ADDENDUM NO. 3

DATE: May 29, 2024

PROJECT: RCSC Middle School – Natatorium HVAC & Lighting Replacement

COMMISSION NO. **SCO** Engineering, LLC – 232710

M0.1

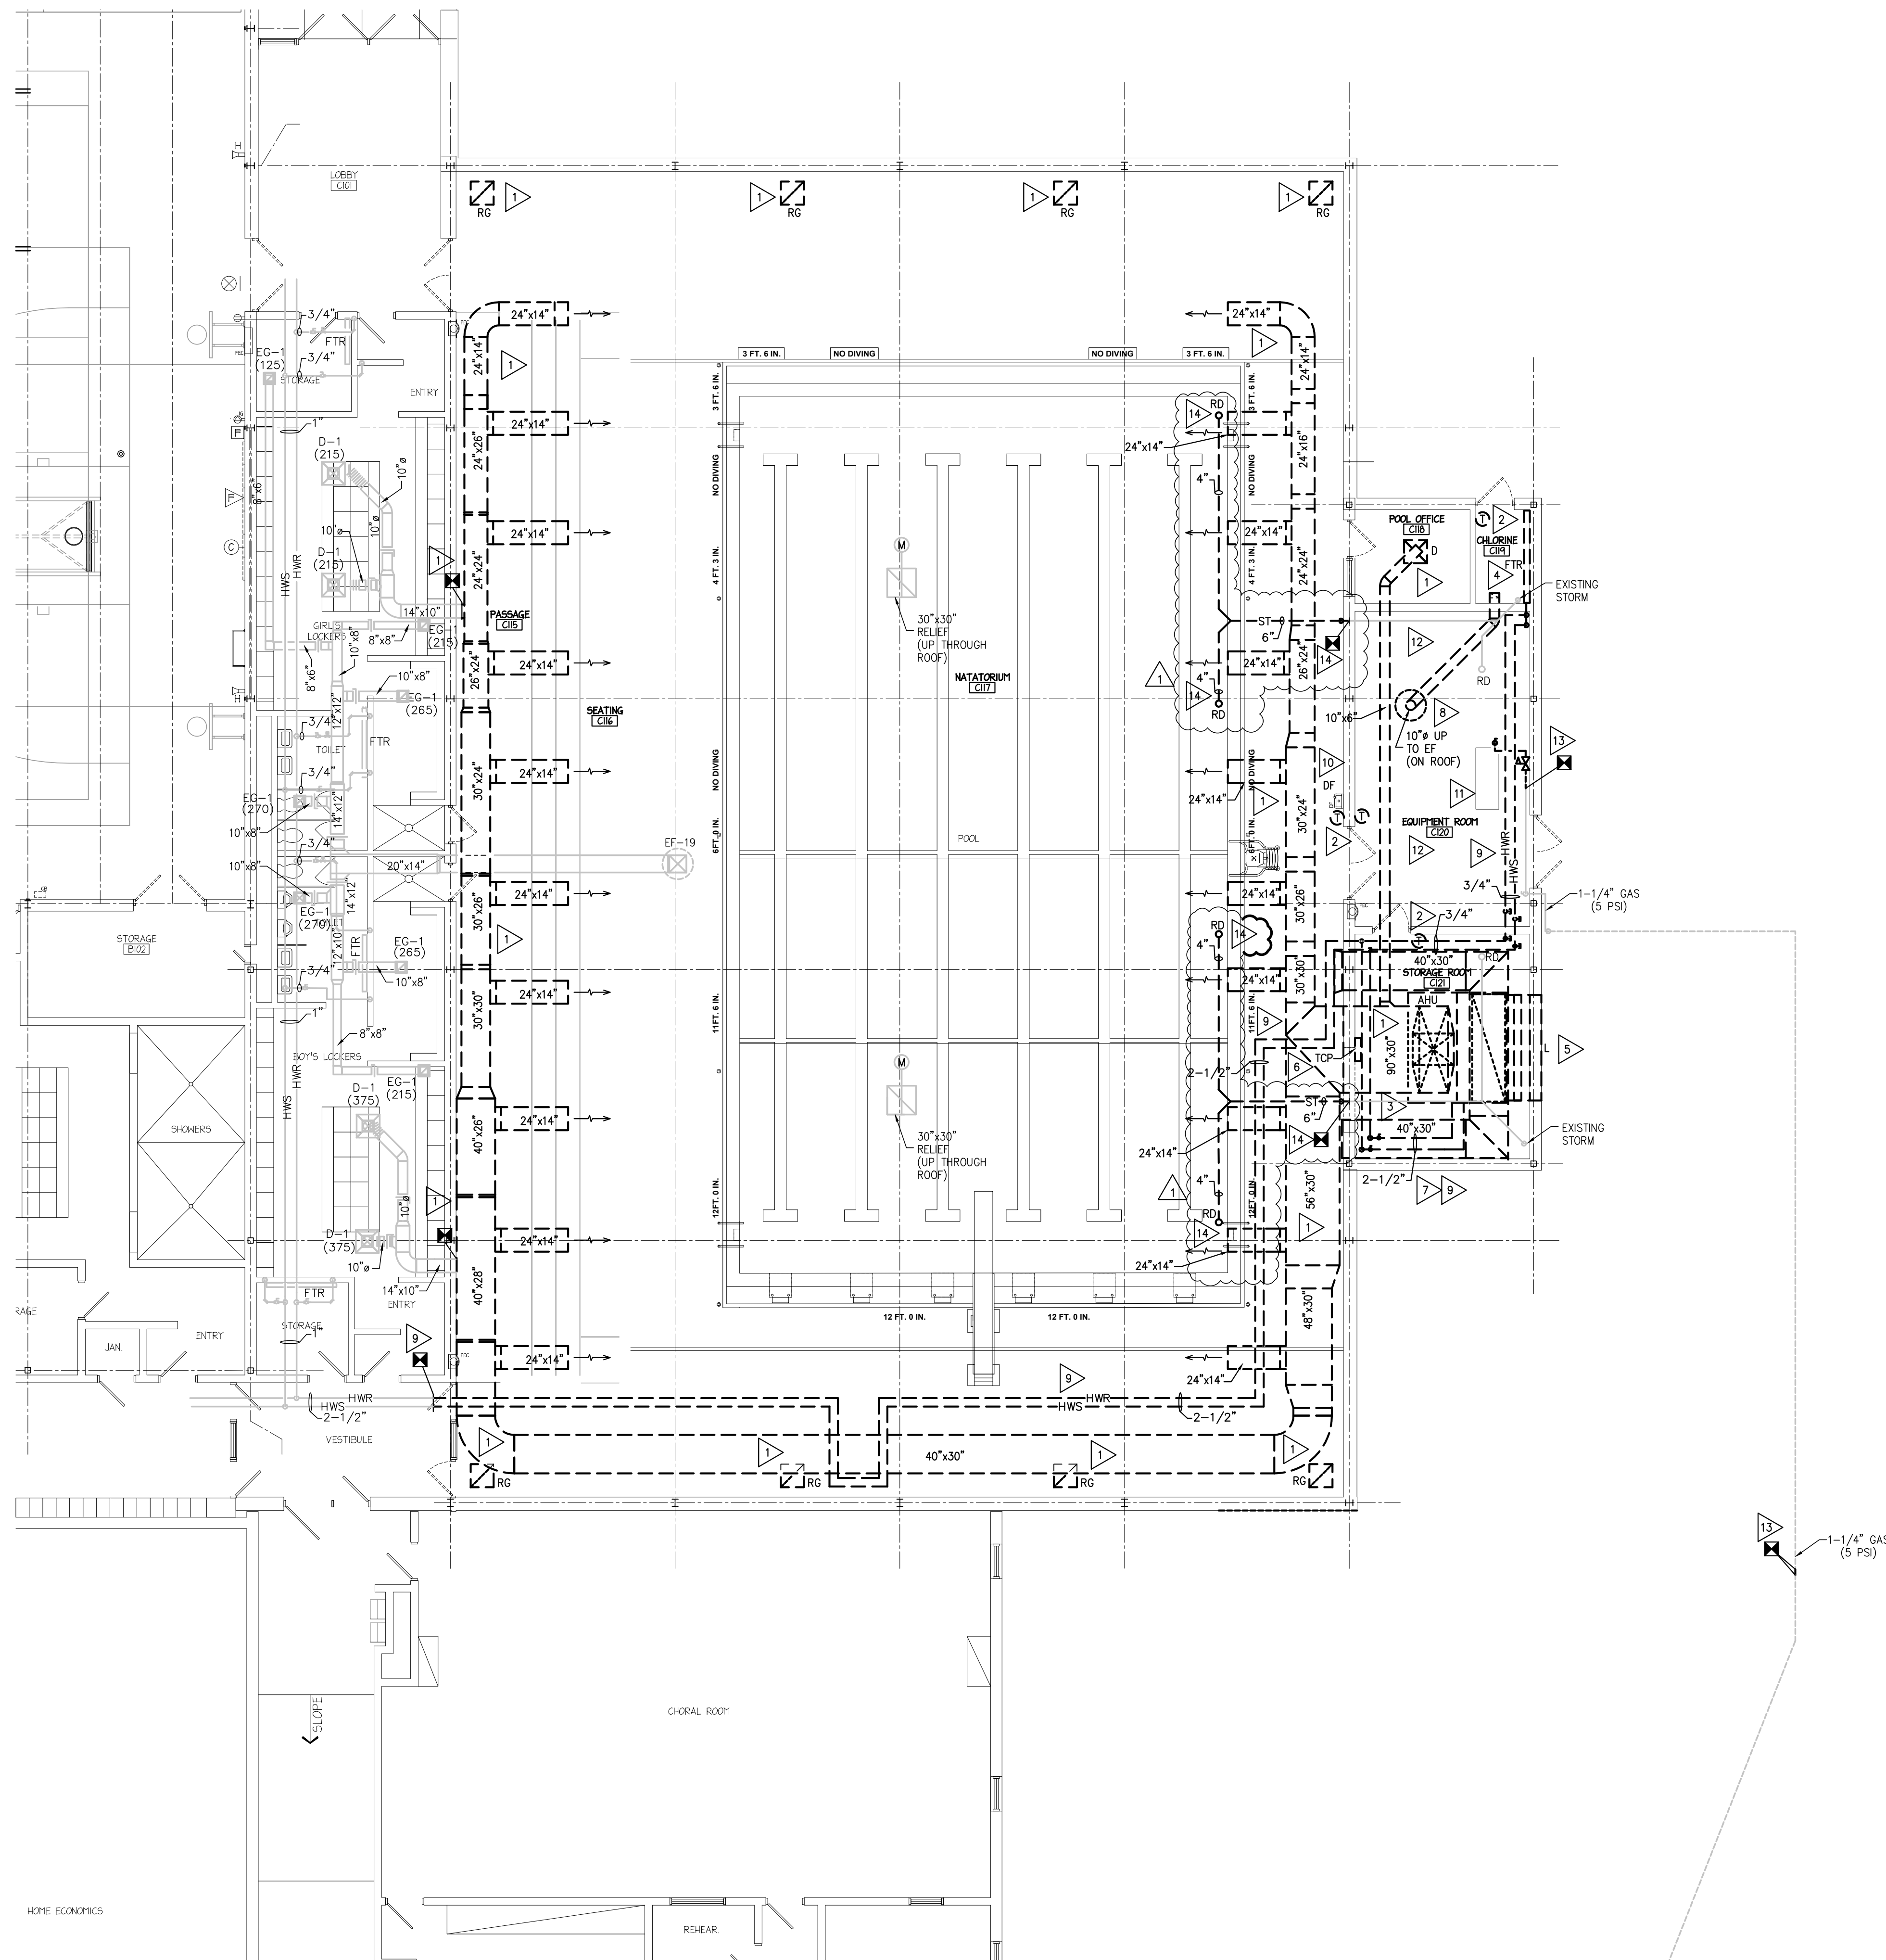
**Item: M-2.1**  
Location: Mechanical Drawing: M0.1.  
Description: Revision: Revise the sheet title scale as shown on attached revised sheet M0.1.

M2.1

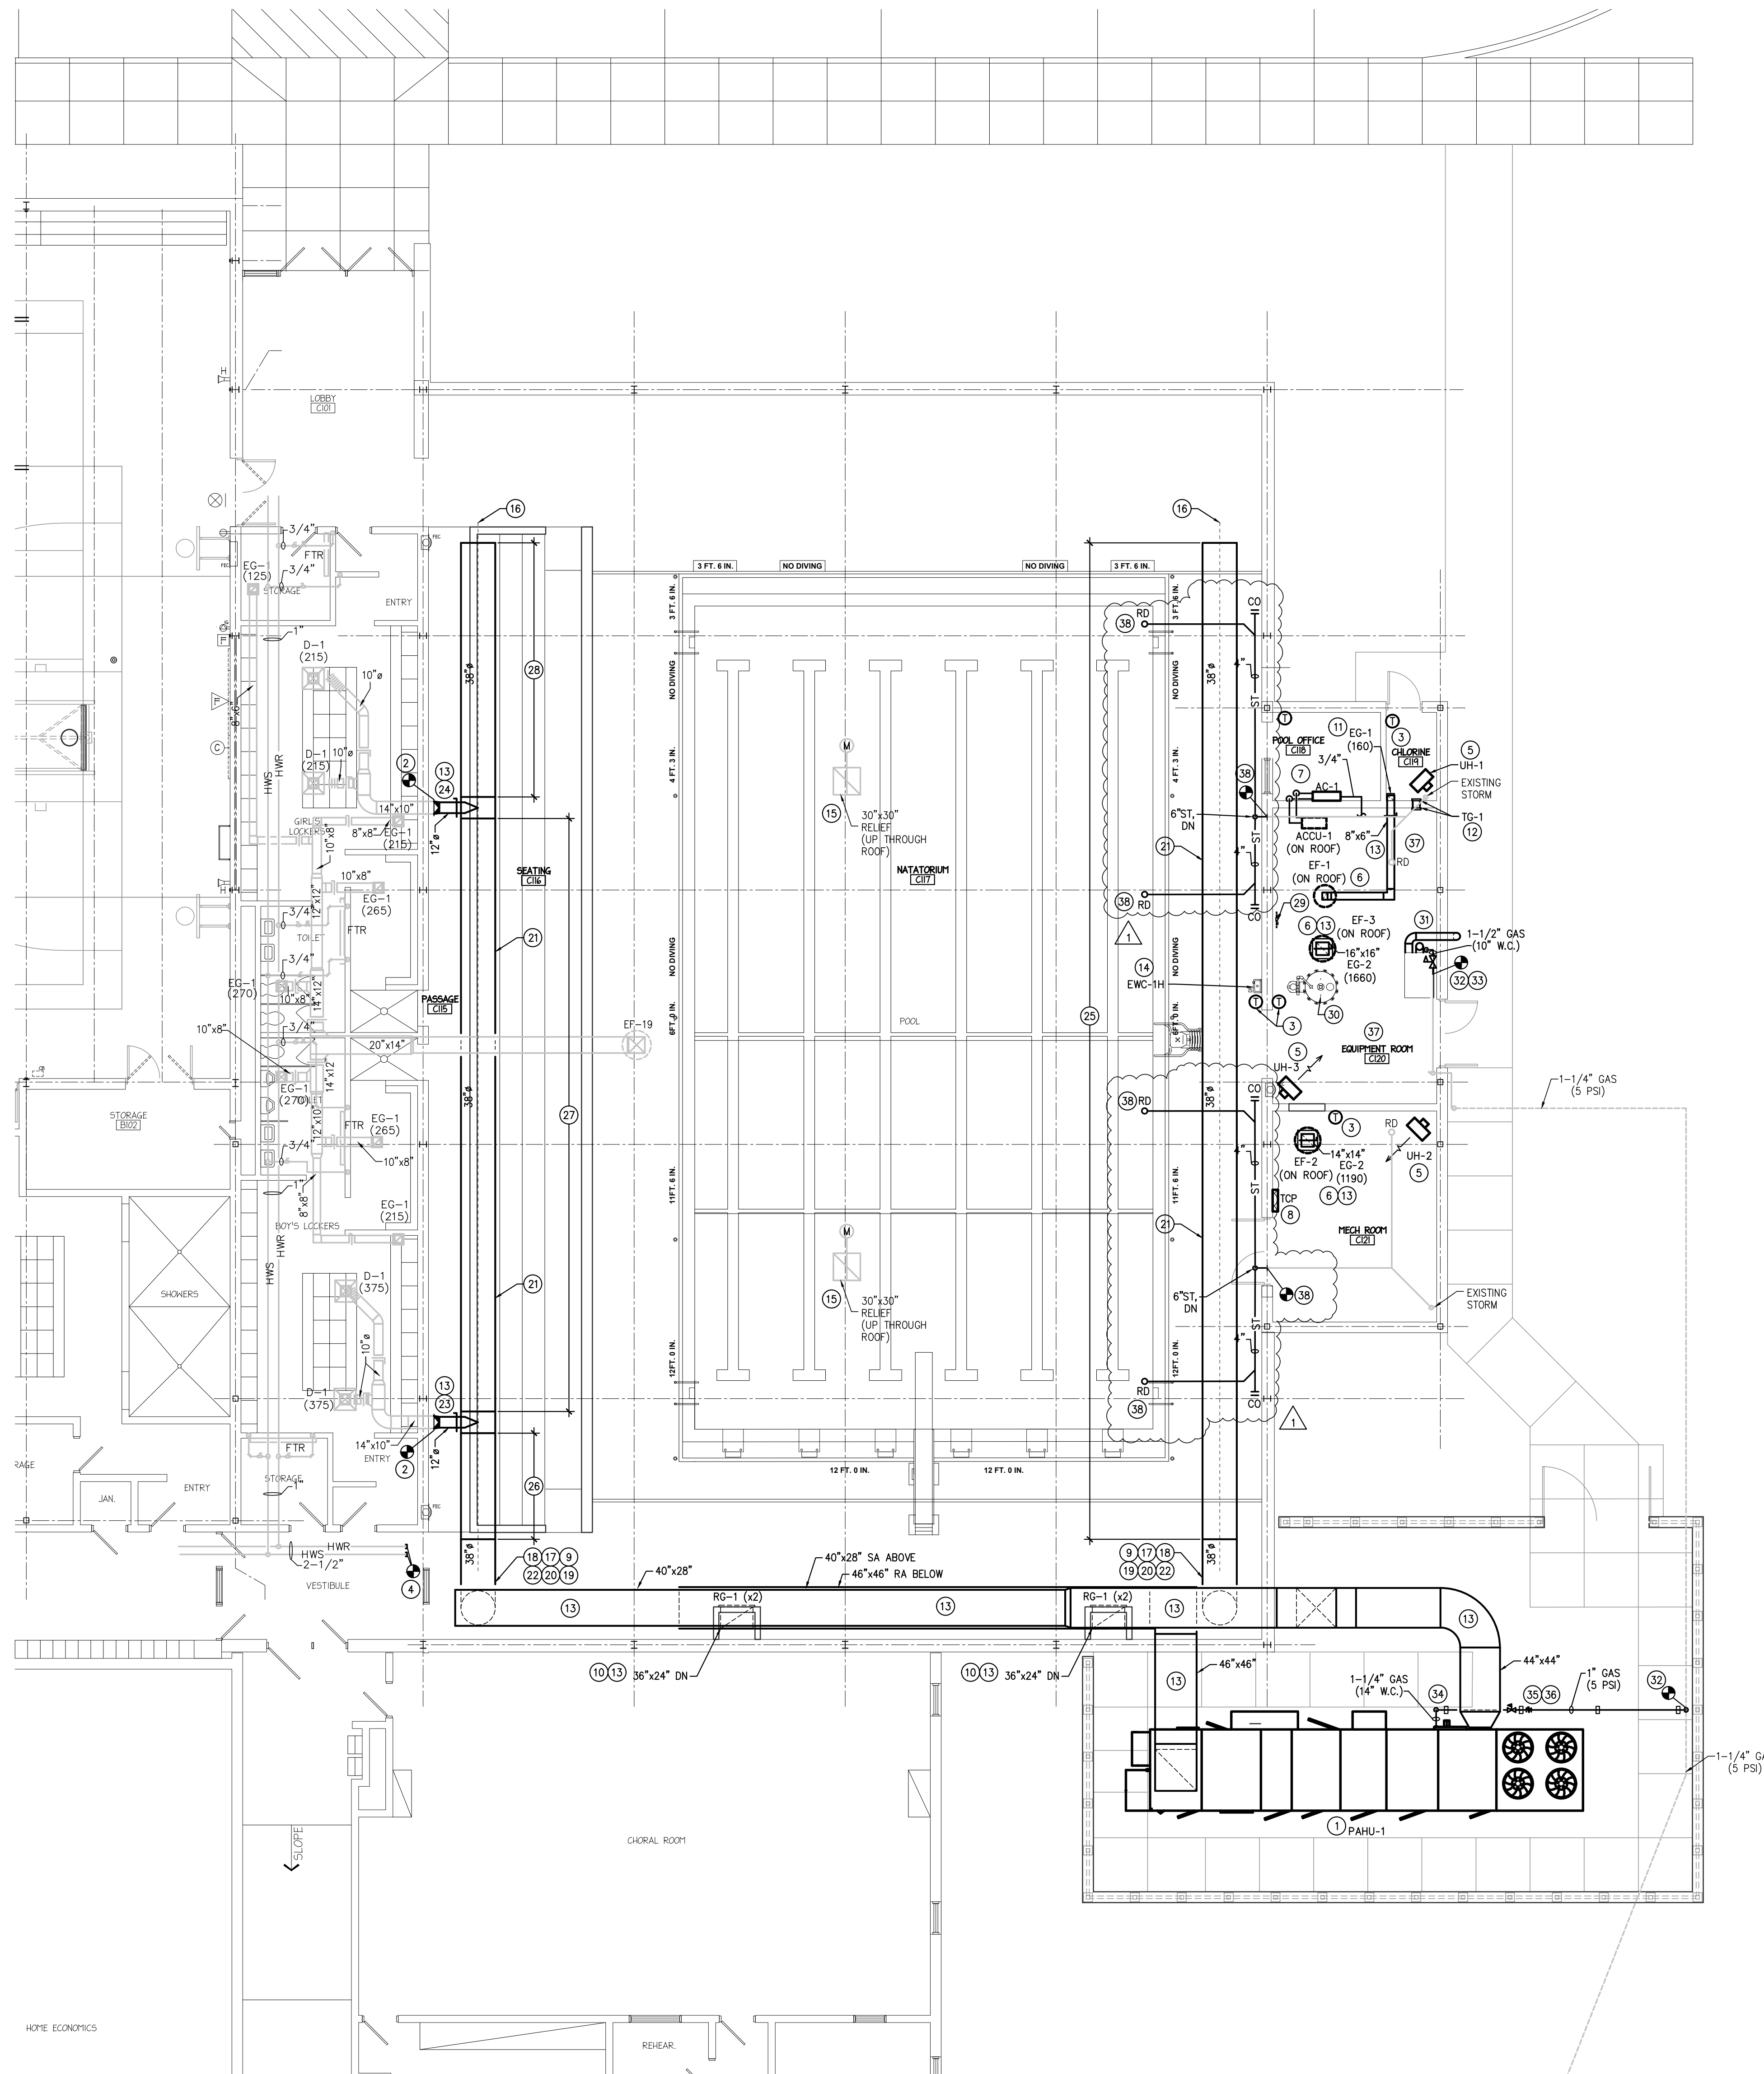
**Item: M-2.2**  
Location: Mechanical Drawing: M2.1.  
Description: Revision: Revise the sheet title scale as shown on attached revised sheet M2.1.
